City of Mississauga Department Comments

File(s): A433.23 Ward: 11

Property Address: 851 Mays Crescent

The applicant is proposing to legalize a widened driveway on the subject property requiring a variance for driveway width.

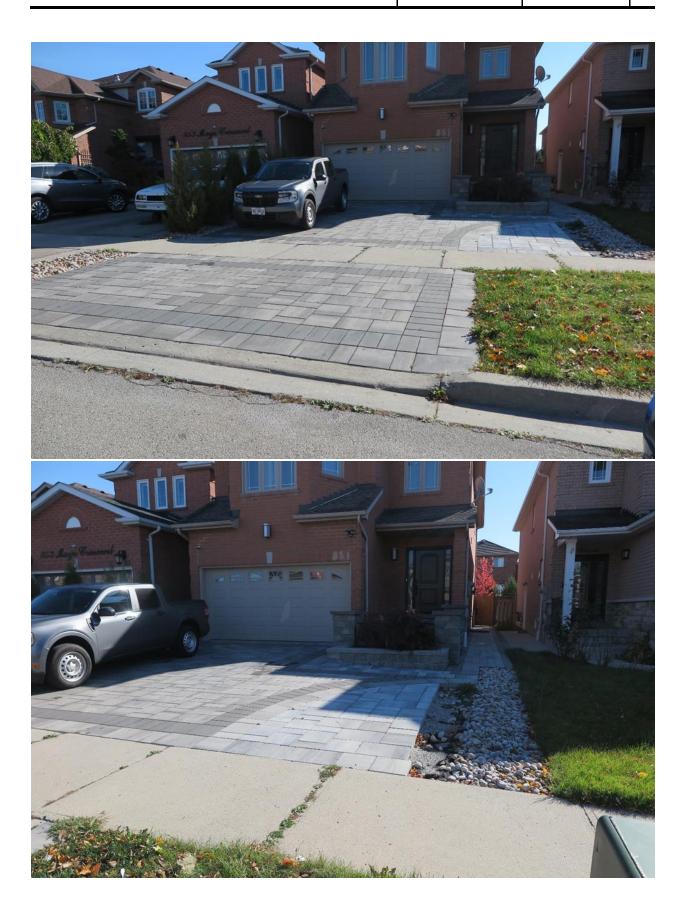
This department notes that with regard to the widened driveway within the municipal boulevard (the area between the municipal curb and property line) we would request that this area be reinstated with topsoil and sod should the application be modified to reflect a smaller driveway width within the subject property or if the application is not supported by the Committee.

It should also be noted that if the existing widened driveway was approved as it exists and utilized for vehicle parking, there would not be an adequate distance from the existing landscape retaining wall to the municipal sidewalk as this length is only 4.7M as opposed to a standard vehicle parking space which is 5.2M in length. In view of the above, we are concerned with any vehicle parking in this area, which would encroach onto the municipal sidewalk, as there would not be an adequate distance to park and manoeuvre a vehicle.
